## Corrections to Change Order 1/24/2023

Corrections to drawing

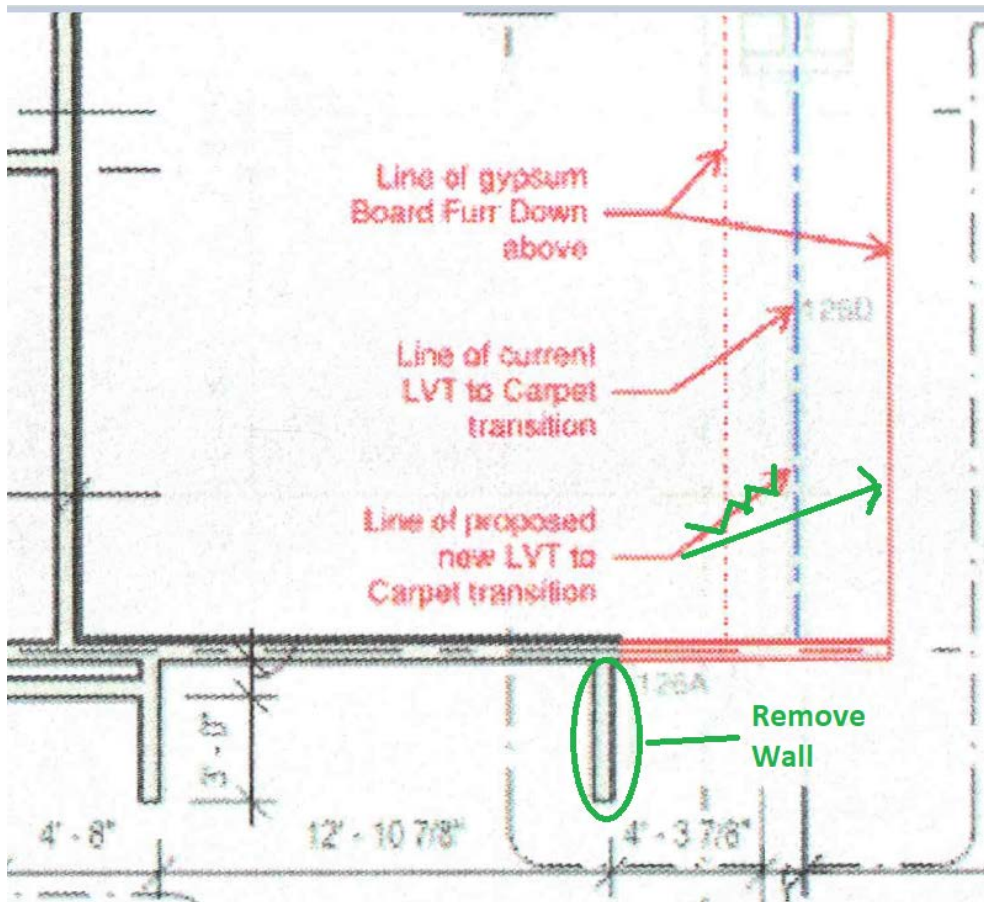
1. The "Line of proposed new LVT carpet transition" points to the same blue line as the "current LVT" transition. I am assuming this is an error and the arrow below in green shows the correct location.
2. Please remove the 3 foot wall separating the copier area from the new wall in the children's area. (see diagram) The copier area and sorting table are so jammed up that there is no room to move anything if the copier, release computer, or coin box need repair.
